SEWAGE DISPOSAL SYSTEM

A REPAIR

SUBDIVISION _____ LOT _____ ROAD 1670 Daisy Road

RE: Building Permit #B00121071
1670 Daisy Road
Proposed Addition

INDICATE NORTH - NAME ADJOINING ROADWAY AS BASE LINE

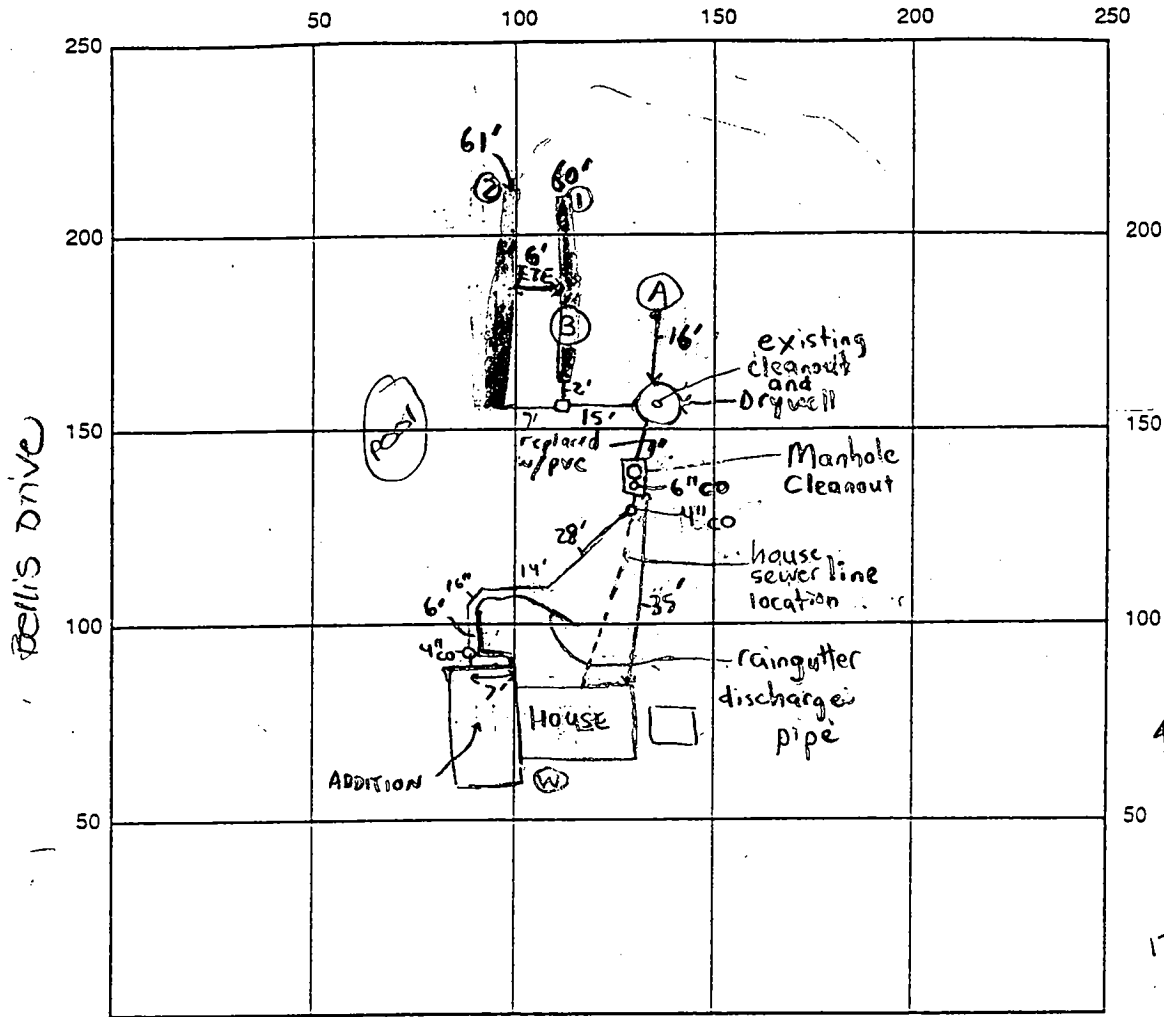
Install trench off existing drywell, along contour,
near perc hole
Trench to be 2' wide, bottom max. depth 12'-13',
inlet 8'-9', stone 4'+.

Daisy Road 4" at addition, 4" at Y connection

CLEANOUTS New 6" on S.T.; New Manhole on S.T.
Existing terracotta on Drywell

DISTRIBUTION BOX LEVEL ✓ Baffle is in

REMARKS: 2/4/00 - MET WITH CONTRACTOR ON SITE, AGREED TO RESCHEDULE INSP TO RESOLVE ISSUES (SRW)

2/7/00 - perc hole dug to 17' - OK to install trenches as specified.

2/8/00 - OK TO COVER ALL WORK (SRK)

INDICATE NORTH. - NAME ADJOINING ROADWAY AS BASE LINE.

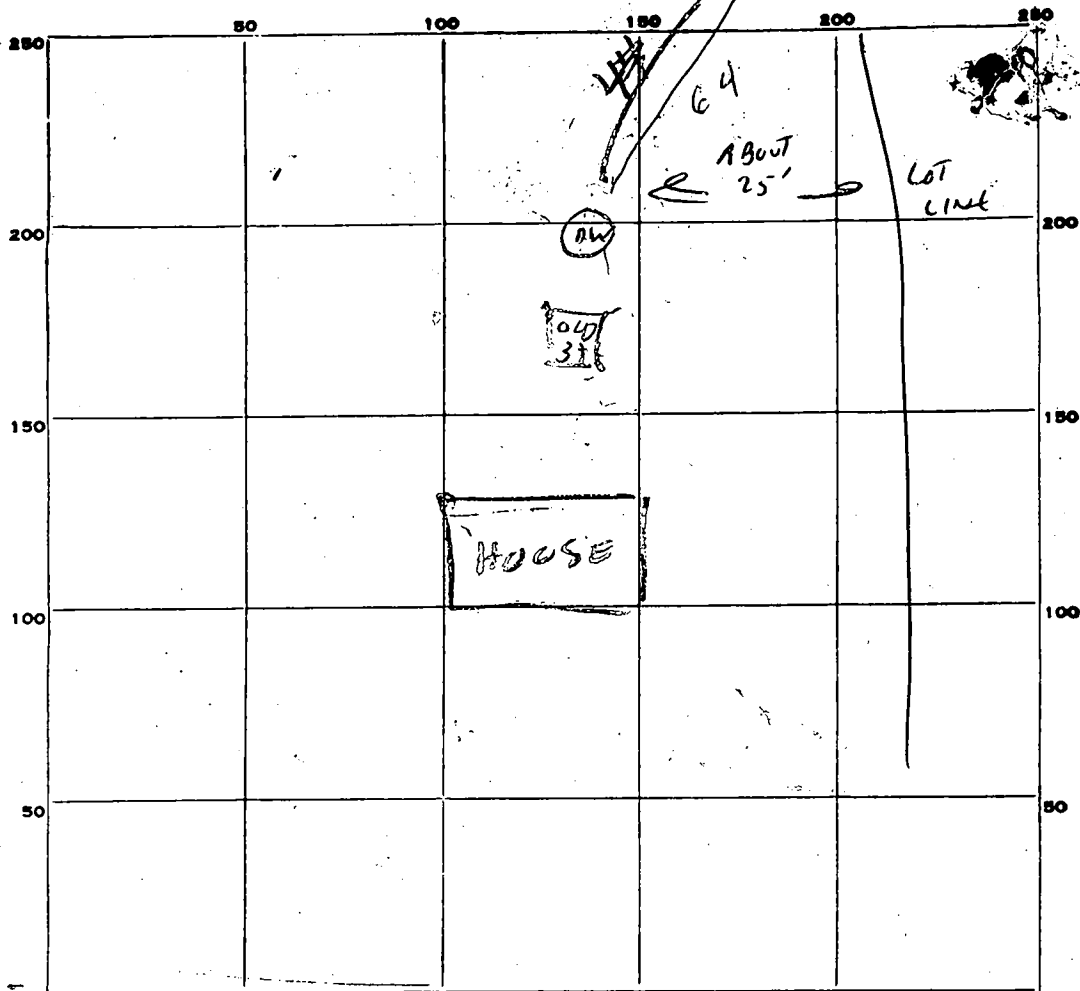
4/27/77 - SOIL POROUS DIG DITCH 12 FT DEEP
2 FT WIDE FILLED WITH 6 FT STONES & 60
FT LONG

REMARKS 4/27/77 - DITCH OK ADD STONE LENGTHEN
DITCH & CALL FOR INSPECTION RIT
